Mitigation Visit Report Creek Road Middlebury, VT
DR-4330

October 23, 2017

By: Richard N. Downer, FEMA Mitigation

Site 1 “H”

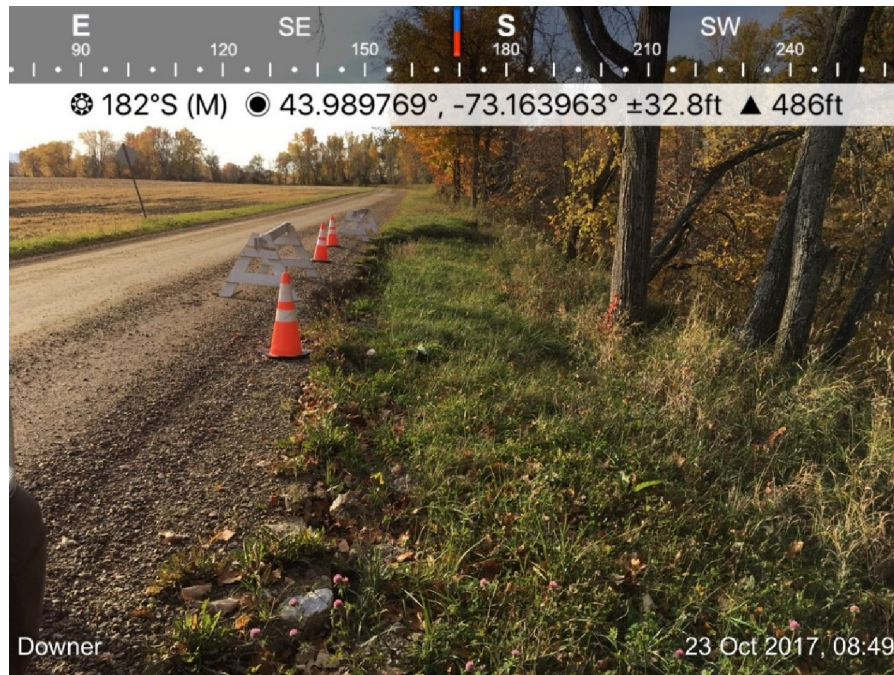
◀ Grassed section of the bank rotated downward about 8 inches. Note that there are no trees on this section. The shoulder of the road did not move.

This section was previously armored with 6-inch stone. The stone is clearly visible in one of the tension cracks. ▼

The bank material does not contain sufficient internal friction to support itself when saturated. The stone riprap added additional weight that that could not be supported.

Do not add more stone or weight. Repair using mechanically stabilized bio-engineering techniques. Insert geotextile, geogrids or geocell layers to add internal friction. Place large rip below water level to protect the bank toe.

Site 3 “J”

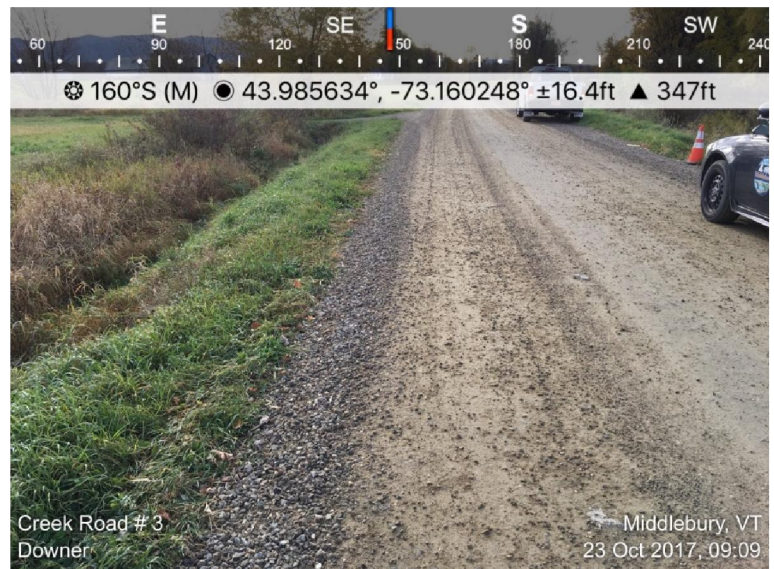
About 6 feet of the bank slipped. The fact that there are no trees on this failed section and that riprap is exposed near the surface suggests the section was previously surface riprapped. ▼

The deep ditch on the east side of the road encourages saturation of the road embankment. ►

Do not add more stone or weight.
Repair using mechanically stabilized bio- engineering techniques.

Insert geotextile, geogrids or geocells layers to add internal friction. Use thick geotextiles that add internal drainage or insert thin layers of free-draining crushed rock. Place large rip below water level to protect the bank toe.

Site 4 "K"

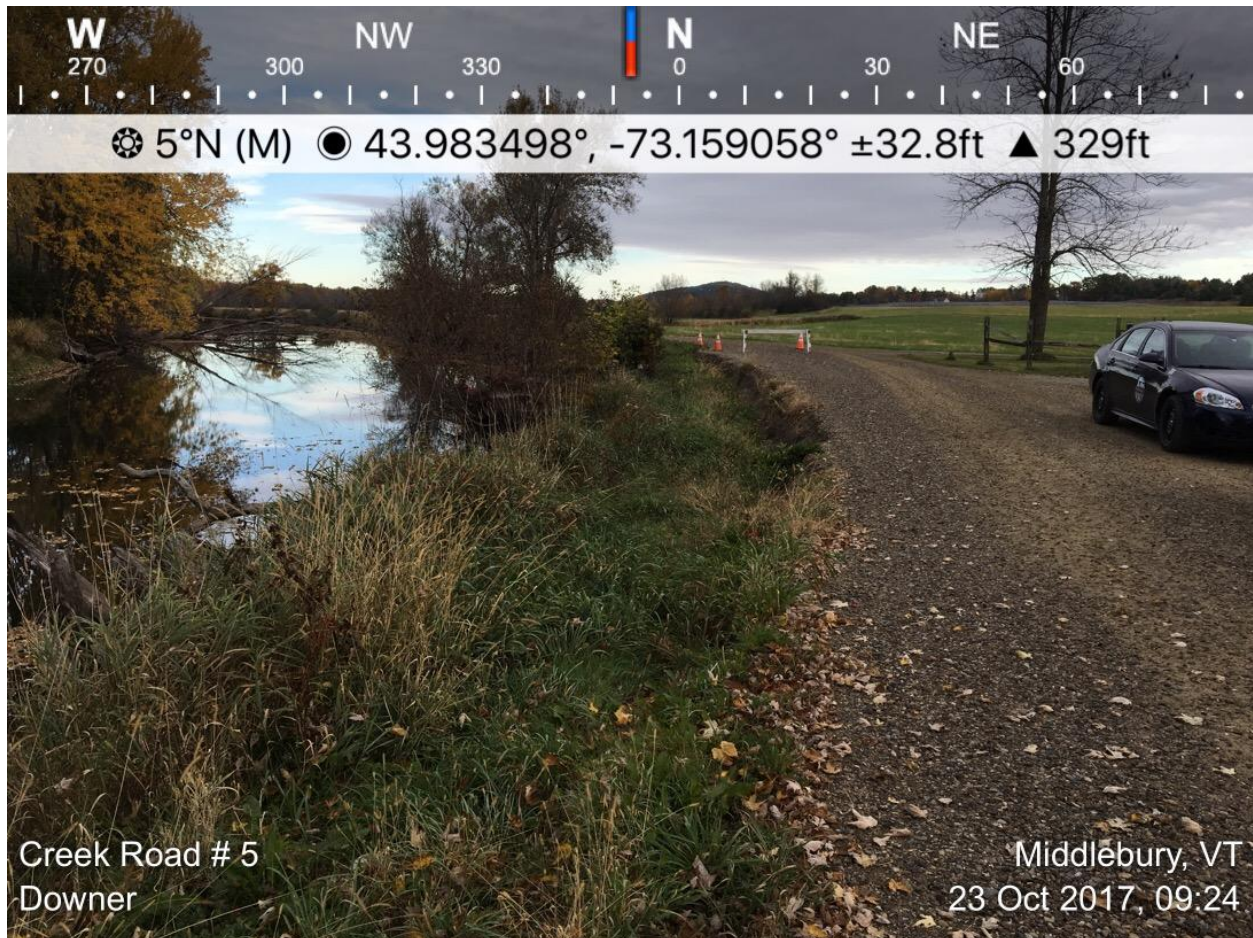
◀ Section was previously cleared of trees and riprapped.

Do not add more stone or weight. Repair using mechanically stabilized bio-engineering techniques.

Insert geotextile, geogrids or geocells layers to add internal friction. Use thick geotextiles that add internal drainage or insert thin layers of free-draining crushed rock. Place large rip below water level to protect the bank toe.
